## aseXML Schema Change Request

<b>Document ID</b>	37
<b>Title</b>	High Speed Monitoring (HSM) additions
<b>Change Type</b>	New transactions and supporting types
<b>Date</b>	10 September 2008
<b>Prepared By</b>	Pius Kurian

Figure 2-1 ElectricityHSMMonitorDataRequestData

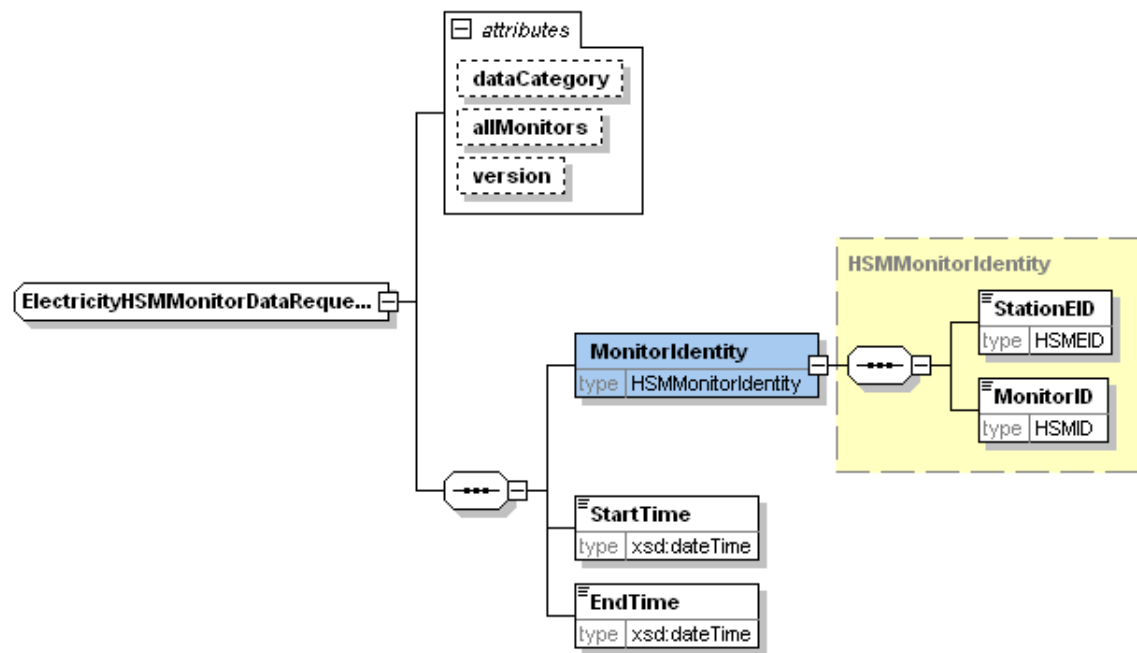
Chg #	Item #	Description of change	Filename
1	1	Add a nillable element HSMMonitorIdentities as choice to ElectricityHSMMonitorDataRequestData in ElectricityHighSpeedMonitoring_r24.xsd file	ElectricityHighSpeedMonitoring
	2	Add an optional attribute 'allMonitors' for ElectricityHSMMonitorDataRequestData in ElectricityHighSpeedMonitoring_r24.xsd file	ElectricityHighSpeedMonitoring
	3	Add a nillable element TriggeredData as choice to ElectricityHSMMonitorDataResponseData in ElectricityHighSpeedMonitoring_r24.xsd file	ElectricityHighSpeedMonitoring
2	1	Modify the Enumeration to specify the transaction types	Enumeration
3	1	Add new include elements for HighSpeedMonitoring and ElectricityHighSpeedMonitoring to schema element	aseXML
4	1	Add new type 'r24' for new schema version	Events

Existing file modified to use NonZeroLengthString type in stead of HSMComtradeTextFile type

<xsd:complexType name="ElectricityHSMMonitorDataRequestData">
  <xsd:complexContent>
    <xsd:extension base="HSMMonitorDataRequestData">
      <xsd:sequence>
        <xsd:element name="MonitorIdentity" type="HSMMonitorIdentity"
nillable="true"/>
        <xsd:element name="StartTime" type="xsd:dateTime"/>
        <xsd:element name="EndTime" type="xsd:dateTime"/>
      </xsd:sequence>
      <xsd:attribute name="dataCategory" use="optional"
default="ContinuousData">
        <xsd:simpleType>
          <xsd:restriction base="xsd:string">
            <xsd:enumeration value="ContinuousData"/>
            <xsd:enumeration value="TriggeredData"/>
          </xsd:restriction>

</xsd:simpleType>
    </xsd:attribute>
    <xsd:attribute name="version" type="r24" default="r24"/>
    <xsd:attribute name="allMonitors" type="xsd:boolean" use="optional"/>
    </xsd:extension>
    </xsd:complexContent>
</xsd:complexType>
<xsd:complexType name="ElectricityHSMMonitorDataResponseData">
    <xsd:complexContent>
        <xsd:extension base="HSMMonitorDataResponseData">
            <xsd:sequence>
                <xsd:choice>
                    <xsd:element name="ContinuousData" type="HSMMonitorData"
nillable="true"/>
                    <xsd:element name="TriggeredData"
type="HSMMonitorData" nillable="true"/>
                </xsd:choice>
            </xsd:sequence>
            <xsd:attribute name="version" type="r24" default="r24"/>
        </xsd:extension>
    </xsd:complexContent>
</xsd:complexType>
